[Docket No. 96-CE-35-AD; Amendment 39-10213; AD 97-24-06]

Airworthiness Directives; Glasflugel Models Standard Libelle and Standard Libelle 201 B Sailplanes

97-24-06. Glasflugel: Amendment 39-10213; Docket No. 96-CE-35-AD.

Appendix to AD 97-24-06—Aileron Actuating Shaft

FIGURE 1

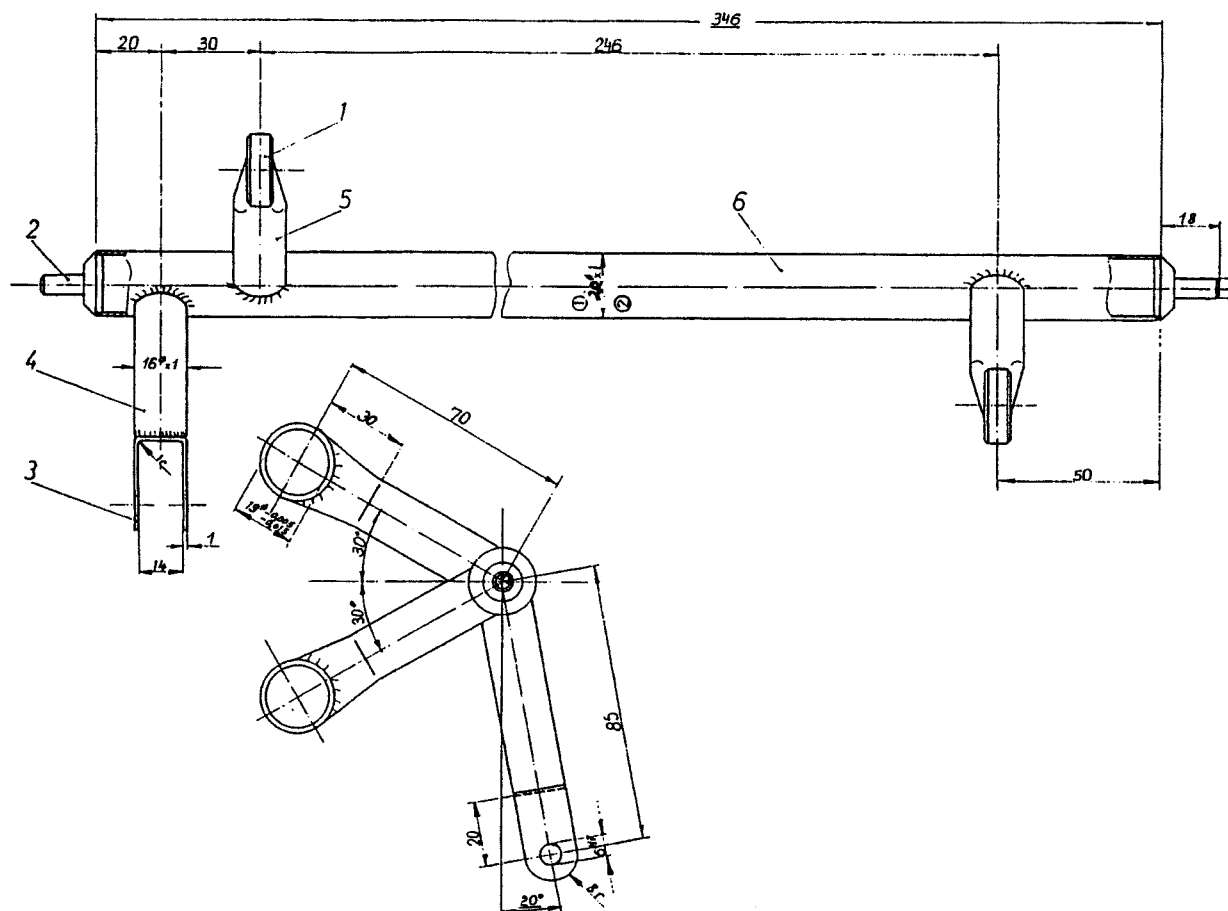
(a) Within the next 30 calendar days after the effective date of this AD, inspect for cracks in the paint of the aileron operating lever's actuating shaft welded seams using a magnifying glass (2x minimum) and a flashlight, and if there are cracks in the paint, then prior to further flight, remove the actuating shaft and perform a dye-penetrant inspection for cracks in accordance with Method 1 in the Accomplishment Instructions section and Figure 1 of the Appendix to this AD.

with Figure 1 and Method 3 in the Accomplishment Instructions in the Appendix of this AD.

Using a magnifying glass (2x minimum) and a flashlight, inspect the aileron actuating shaft in the fuselage (see Figure 1) near the welding seams for cracks in the paint. If there is any cracked paint on the actuating shaft, prior to further flight, remove the actuating shaft and inspect for cracks in the shaft and welding seams using a dye-penetrant method. If there are no cracks or any other damage, flying operation can continue until the accumulation of 8 calendar months after the initial inspection required by this AD, at which time Method 2 or Method 3 shall be accomplished. If cracks are found, prior to further flight, accomplish Method 2 or Method 3.

As an alternative to Method 2, replace the original actuating shaft with a new reinforced shaft according to Figure 1.

Remove all paint. Weld (groove welding) all cracks. Weld the joints with the WIG-inert protective atmosphere welding system (wolfram inert gas welding system) with welding material 1.7734.2. Weld the plates (position 7) to the actuating shaft according to Figure 2. Finish the actuating shaft with primer and paint (paint type RAL 7003). Reinstall the aileron actuating shaft.

For rigging and derigging procedures, refer to the flight manual, page E12. After accomplishing repairs according to Method 2, or replacement of the actuating shaft according to Method 3, the aileron deflections must be checked. Plates, welding material, and spare parts as mentioned are available from the manufacturer.
